Interactive comment on “Study on organic matter fractions in the surface micro layer in the Baltic Sea by spectrophotometric and spectrofluorometric methods” by Violetta Drozdowska et al.

Violetta Drozdowska et al.

Reviewer #2:

Figure 3. The relationship between salinity and: (a) the spectral slope coefficient, S_0 , measured in the 200–600nm, (b) the slope ratio $S_0 = S_{200-250} / S_{500-600}$ and (c) the relative changes in the molecular weight, MW (E_2/E_3) for SS; and: (d), (e) and (f) for SML, respectively.

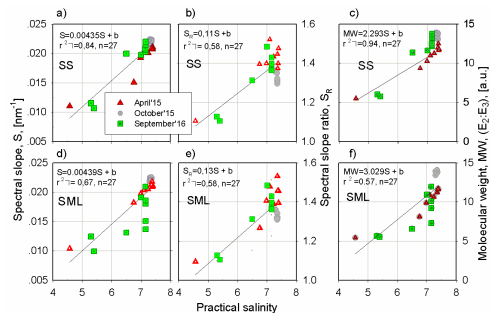
6. Fig. 3 - incorrect legend. I corrected the legend.
